**SOUTHERN CALIFORNIA EDISON
KERN RIVER NO. 3 HYDROPROJECT**

DOCKET NO. P-2290-122

**KERN RIVER BOATERS' COMMENTS AND
STUDY REQUESTS IN RESPONSE TO THE KR3
INITIAL STUDY REPORT AND ISR MEETING**

Edison: Figure 5.1-4. Monthly Mean Flow in the North Fork Kern River for the Fairview Bypass Reach and the Kern River No. 3 Water Conveyance, Water Years 1997–2022.

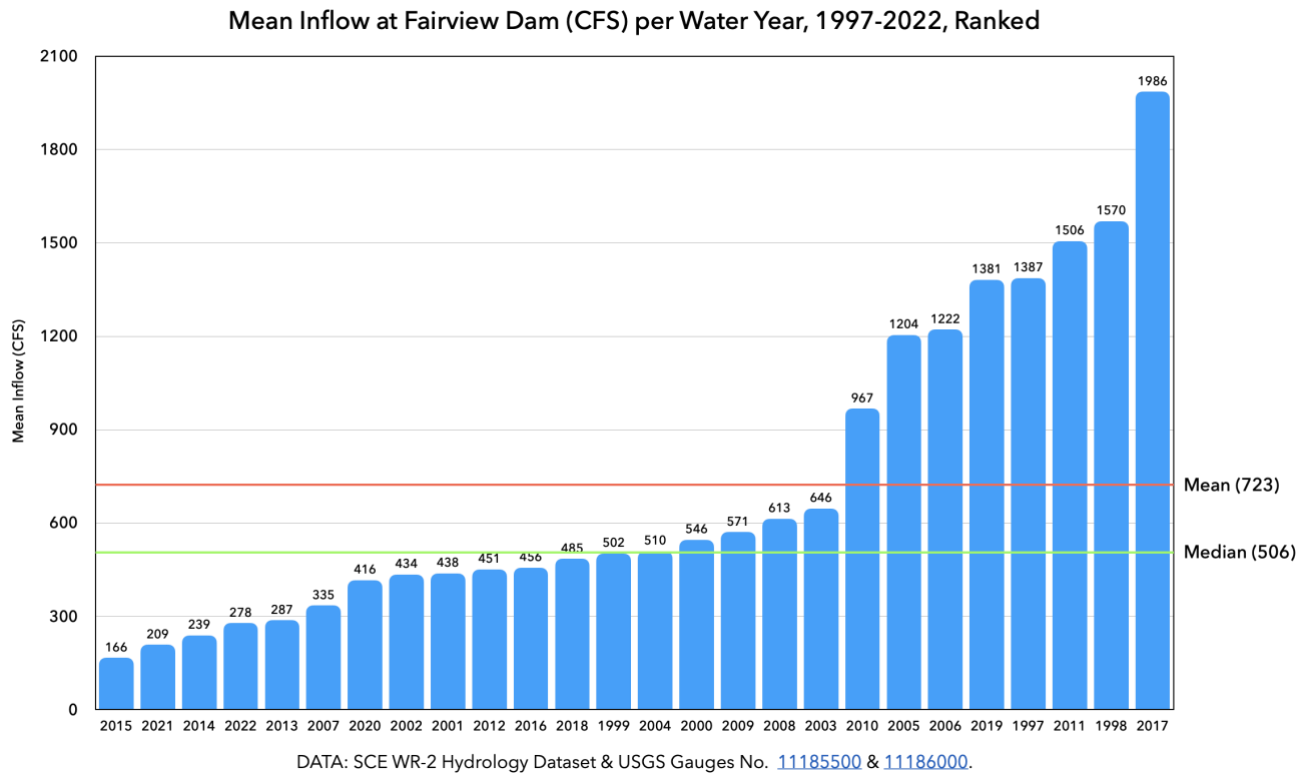
KRB: As indicated by several participants at the October 17, 2023 ISR meeting, Edison’s use of the monthly *mean* for figure 5.1-4 (above) misleads its intended observers — governing agents and stakeholders — about typical project effects. It does so to such an extent it constitutes a variance from the study plan.

The mean is an appropriate representation of a system’s central tendency when its distribution is symmetrical. The distribution of water years in the NF Kern watershed is not symmetrical. Rather, it is asymmetrical, skewed by the presence of outlier high water years up to four times greater in water volume than the median. As a result, representing monthly flows over the years with the mean, as in Edison’s Figure 5.1-4, does not fairly represent the central tendency of project effects. Instead, it gives undue weight to a small proportion of extremely large values, namely, a small proportion of high-water years.⁵

We agree with Edison’s methodology in the PAD (monthly medians) rather than its methodology in the ISR (monthly means). The monthly mean over-represents outlier high water years that misleadingly pad the typical quantity of flow below the diversion. The central tendency of project effects in this watershed — *i.e.*, those effects most likely to be faced by the living things dependent on the quantity of water flowing below Fairview Dam — are best represented, in monthly increments, by the monthly median, not the monthly mean.

Figure 2: Dimensionless Hydrograph for Observed above Fairview Dam (left) vs Authorized below Fairview Dam (right). Red line represents 50th percentile; light blue lines are 25th and 75th; dark blue 10th and 90th percentiles.

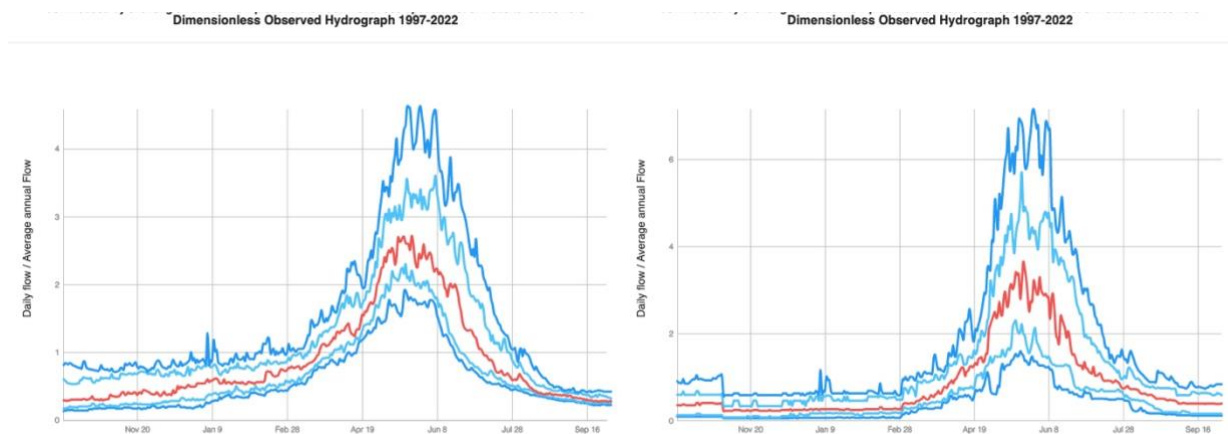
As a part of the eFlows analysis, plots were generated depicting the representative hydrographs for the analyzed datasets. Representative hydrographs comparing the observed data above Fairview Dam to the authorized flow below Fairview Dam can be seen in Figure 2. Within these plots, it is possible to view the flattening (both in magnitude and variability) of the dry season flows, as well as the reduction in magnitude and duration of the wet season in low or median years.

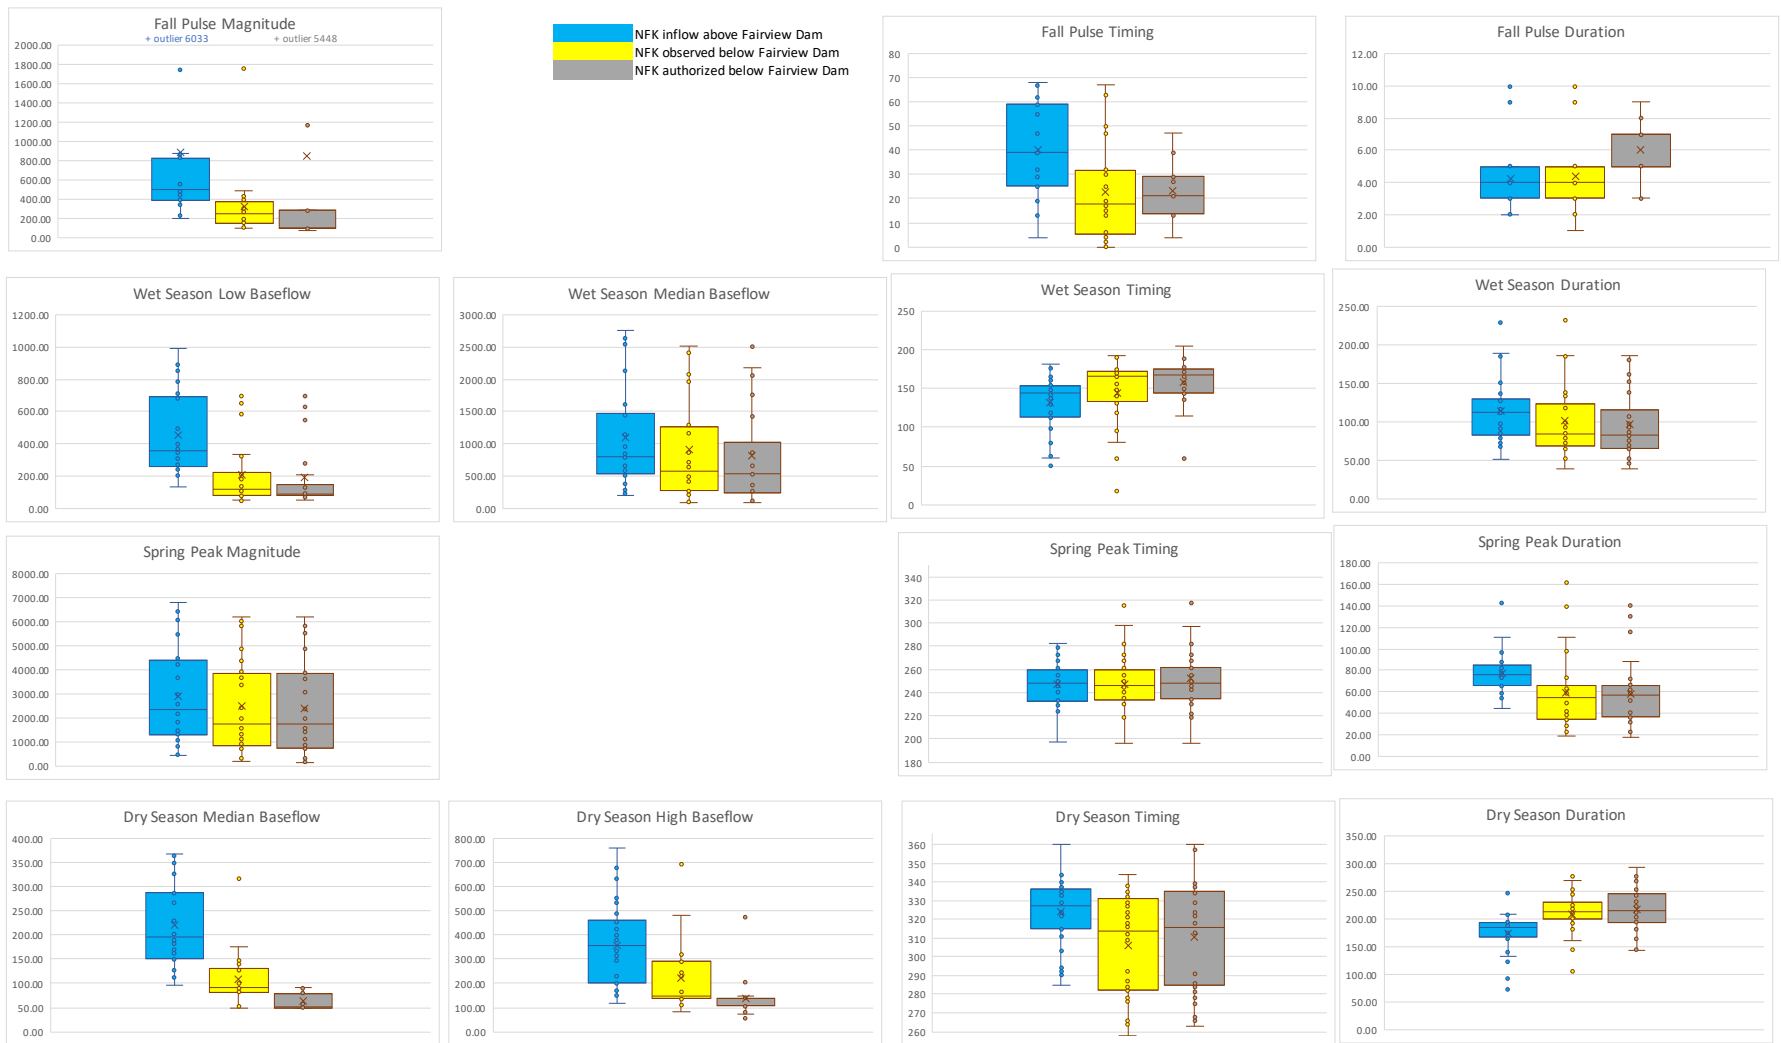
Next, Figures 4 and 5 provide the box and whiskers plots corresponding to each of the datasets included in the analysis. In Figure 4, the Estimated above Fairview Dam values (obtained from the Natural Flows database) are plotted against the Observed above Fairview Dam dataset. This step was taken to verify the datasets used, and to examine how well the database estimates correspond to the observed dataset. It indicates that the estimated model is closely aligned to the 26-year observed dataset, and SCE's choice of using the estimated data in the study report (rather than the observed data on hand) was not impactful.

Finally, Figure 5 plots the FFM distributions for 1) the observed data above Fairview Dam, 2) the observed data below Fairview Dam, and 3) the authorized flow dataset below Fairview Dam. From this comparison, two major conclusions about the Authorized flows below Fairview Dam (FVD) can be reached:

Figure 5.1-8. Comparison of Annual Number of Days Flows are > 700 cfs above Fairview Dam and in the Fairview Dam Bypass Reach, WYs 2005–2021.

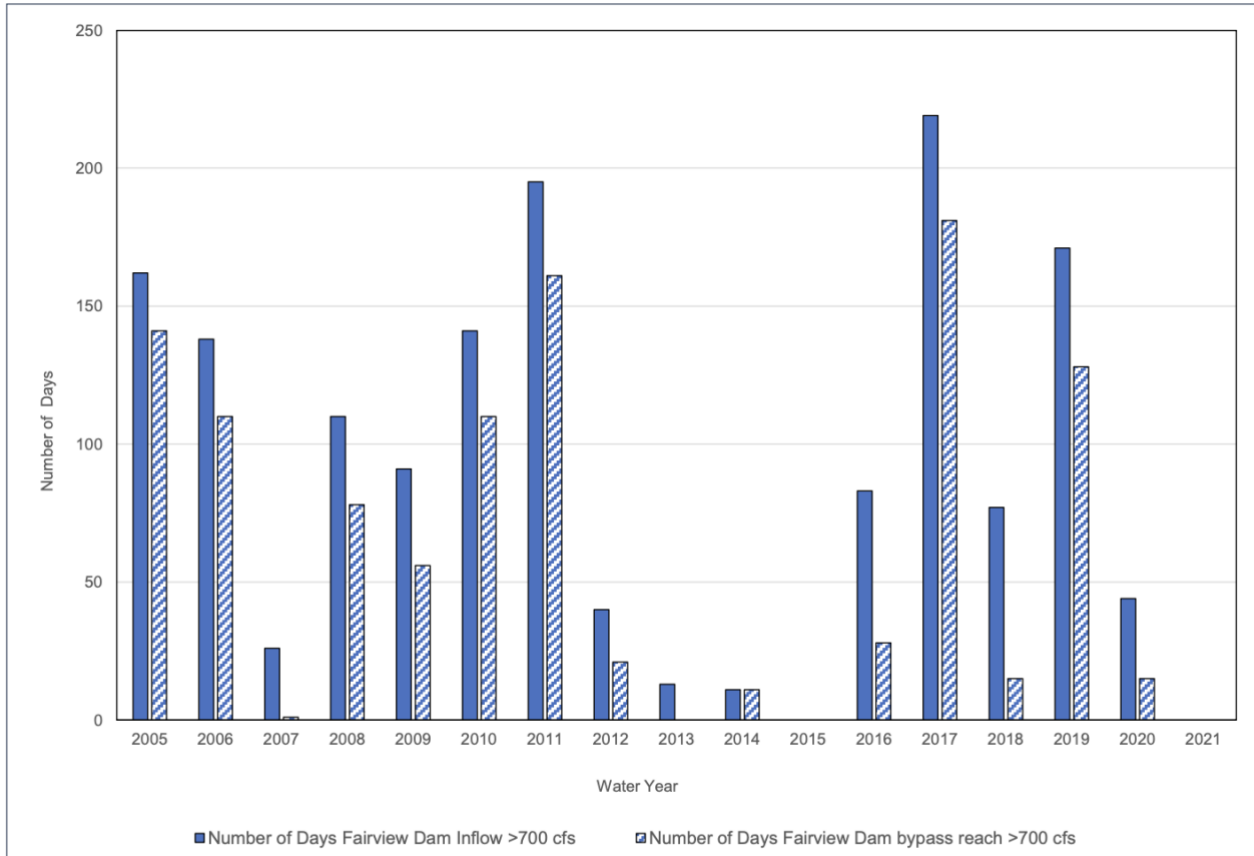
Confronted with these facts at the ISR meeting, Edison’s consultant averred that he chose the 700 cfs figure not based on Article 422 releases, but rather on the 1994 whitewater study. That cannot be true either, as the 1994 study found adequate flows for enjoyable class 2-3 boating at 500 cfs and enjoyable class 3-4 boating at 550 cfs³⁵:

It ignored these facts because it is in Edison’s interest to keep the definition of a “boating day” at a higher level rather than one lower: project effects in removing boating days increase dramatically as the flow required for a boating day decreases.

In the following graph, we used the same dataset Edison used for Figure 5.1-8 save one: we decreased the flow required for a boating day from ≥ 700 cfs to ≥ 500 cfs³⁶:
